Monthly Specification Update

Intel® Server Board S3420GP

Intel Order Number E82362-006

May, 2011

21. Intel® Matrix Storage Manager of Intel® Rapid Storage Technology (Intel® RST) may show HDD incompatible status under certain conditions

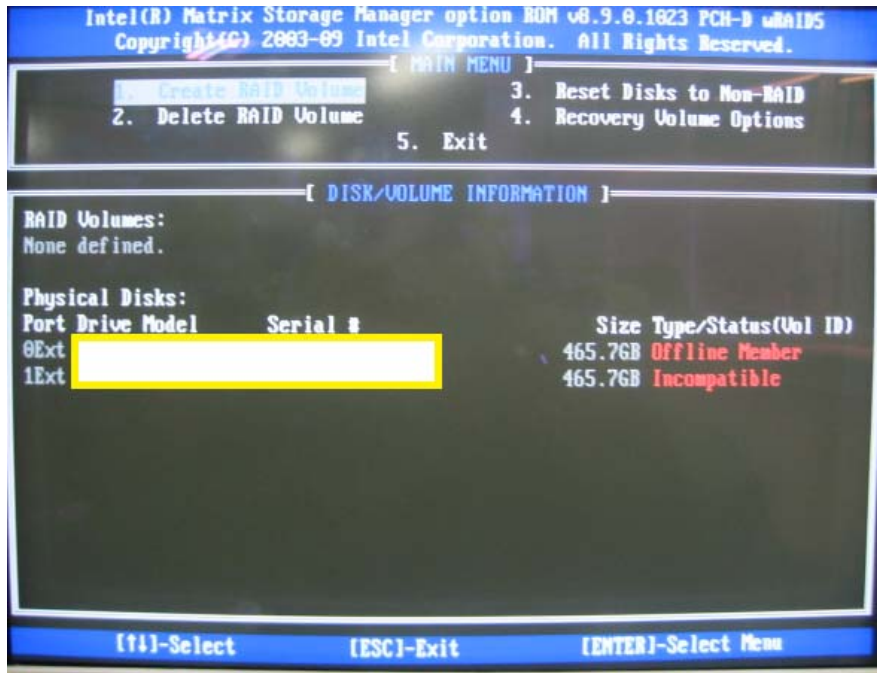
Problem	Under RAID 1 mode, if the operating system does reboot after one HDD is unplugged, the other HDD will show incompatible status even after the other HDD is plugged in again.
Implication	Please refer to the picture below.

Status This issue was fixed in BIOS version 0048.

Workaround Downgrade BIOS to version 0042 when the issue is happening.
